## REVISED RESPONSE TO REQUEST FOR ADDITIONAL INFORMATION

### APR1400 Design Certification

RAI No.: 255-8285  
SRP Section: 03.08.05 – Foundations  
Application Section: 03.08.05  
Date of RAI Issue: 10/19/2015

### **Question No. 03.08.05-13**

Figure 1 Jurisdictional Boundary for Design of Common Basemat

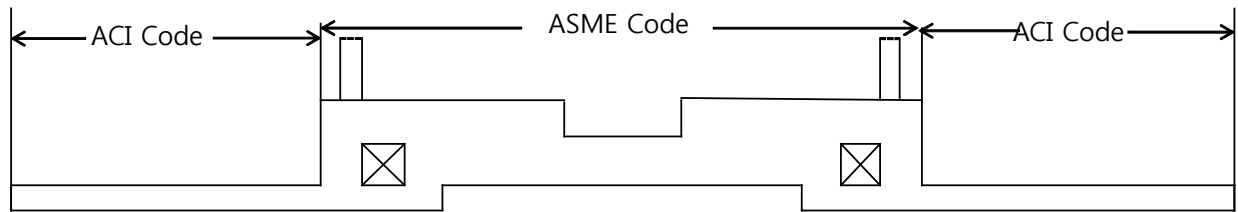
Technical Report (TR) APR1400-E-S-NR-14006-P, Rev 1, "Stability Check for NI Common Basemat," Section 3.2.6, "Load Combinations," states that, "The division of the basemat by code jurisdiction at the thickness transition is a logical choice, and the boundary of the code jurisdiction is conservatively designed using the greater forces from the analysis results of ASME and ACI codes." It is not clear to the staff as to how the applicant consider the loads and load combinations for the basemat of the containment and the Auxiliary building (AB), and how the applicant design the transition region. For example, it is not clear whether the division of the basemat code jurisdiction at the thickness transition is in accordance with the ASME Code Interpretation: 111-2-83-01, which covers this design configuration and how do they define the transition region. Per 10 CFR 50.55a; Appendix A to 10 CFR Part 50, General Design Criteria 1, 2, 4, 16 and 50; and SRP 3.8.5, the applicant is requested to describe in more detail how the loads and load combinations for the basemat of the containment and the AB, were considered in the analysis and how the transition region is design.

Load combinations and load factors for the RCB and the AB basemats are selected based on their relevant design codes, ASME and ACI respectively. The boundary of code jurisdiction between the ASME code and the ACI code is shown in Figure 1. The details of the code jurisdiction boundary are presented in the response to RAI 199-8223, Question 03.08.01-11.

requires that the concrete containment should meet the Factored Load Category requirements of ASME Section III Div.2 CC-3720, which is related to allowable strain of the liner plate, for integrity of containment. Therefore, the combustible gas load due to hydrogen generation is only considered in the structural integrity assessment based on deterministic design basis analysis, and is not considered in the determination of structural member forces for design. In addition, the evaluation of the combustible gas load is executed under pressure boundary conditions in accordance with ASME CC Code. Note that in the case of auxiliary building design (which does not follow ASME CC), the evaluation of combustible gas load is not necessary for the auxiliary basemat. Therefore, the basemat, which is classified as a ACI Code boundary (see Figure 1), is not included in Table 2.

For the design of the basemat, at the interface between the ASME and ACI codes, the larger amount of reinforcement required by either code was used.
